Panel Reference	2017SSH023
DA Number	DA2017/0138
LGA	Georges River Council
Proposed Development	This application seeks development consent for consolidation of the existing allotments, demolition of existing structures, site remediation and construction of a mixed use development. The proposal includes a supermarket and two (2) retail tenancies with shop top housing for forty (40) units and three (3) basement levels of car parking including loading facilities.
Street Address	160-178 Stoney Creek Road Beverly Hills
Applicant/Owner	Applicant: SJB Planning Owners: Cuzeno P/L
Date of DA lodgement	18 May 2017
Number of Submissions	Two (2) submissions one containing seven (7) signatures to the amended proposal.
Recommendation	Refusal
Regional Development Criteria (Schedule 7)	Regional Development is defined in Schedule 7 of State Environmental Planning Policy (State and Regional Development) 2011. Development with a capital investment value (CIV) over \$20Million The CIV of this application as outlined in the Registered Quantity Surveyors Detailed Cost Report is \$22,357,500.

Addendum Report

Executive Summary

Figure 5 Extract North and South elevation demonstrating the extent of the variation to height (Candelapas Associates, 2017)

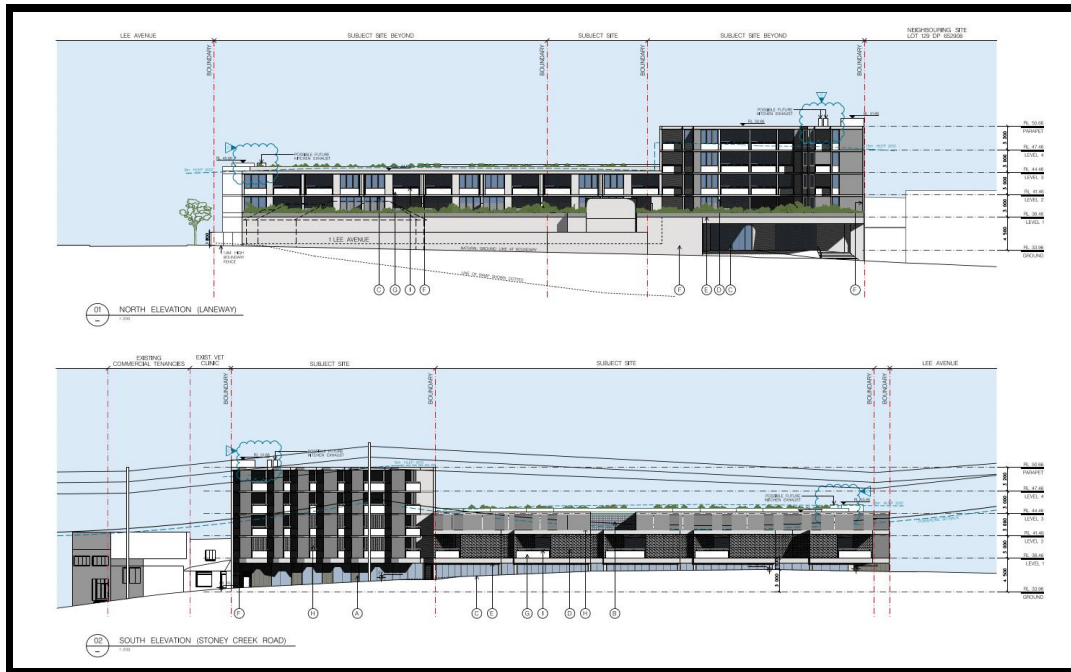
Officer Comment: A Clause 4.6 Exception to Development Standard for a breach in height is sought whereby the development exceeds the prescribed height of contained in the LEP, being a maximum of height of 17.92m (+19.4%) along the western portion. Clause 4.3 is not a clause excluded under Clause 5.4 Controls relating to miscellaneous uses under the HLEP 2012. The applicant has demonstrated the extent of the variation within the following architectural extracts below;

Comment: The applicant's Clause 4.6 Exception for Development Standard relating to Clause 4.3 - Height of Building is not supported as the extent of the variation is not in the public interest as it is inconsistent with the objectives of the relevant standard and objectives of the zone as it will create a development form that was not envisaged in this location due to the excessive bulk and massing.
